1973 Corvette: Service Bulletin: Exhaust Manifold Heat Shielding

73-T-8
 Number:
 Ia
 Section:
 Jan. 3, 1973
 Date:

Subject: EXHAUST MANIFOLD HEAT SHIELD -
 1973 CORVETTE WITH 350 CU. IN.
 ENGINE WITH AIR CONDITIONING

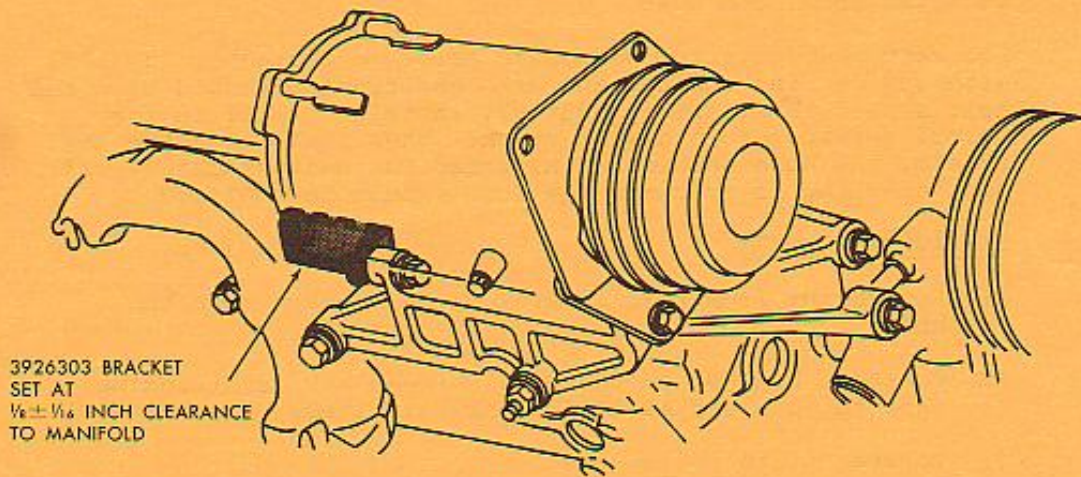
Some early production 1973 Corvettes equipped with 350 cu. in. engines and air conditioning may experience air conditioning hose damage due to close proximity of the exhaust manifold.

Corvettes assembled after September 13, 1972, have a heat shield installed between the hose and the manifold to protect the hose from heat.

For service, Corvettes assembled prior to September 13, 1972, with 350 cu. in. engines and air conditioning should have the heat shield, Part Number 3926303, installed while in for normal service or in dealer stock. When installing the heat shield, the hose should be inspected for heat cracking. If heat cracking is evident, the hose should be replaced.

- 1) Remove nut from rear compressor to bracket mounting bolt.
- 2) Position bracket on bolt and between air conditioning suction hose and manifold as illustrated.
- 3) Torque nut to 25 ft. lbs.
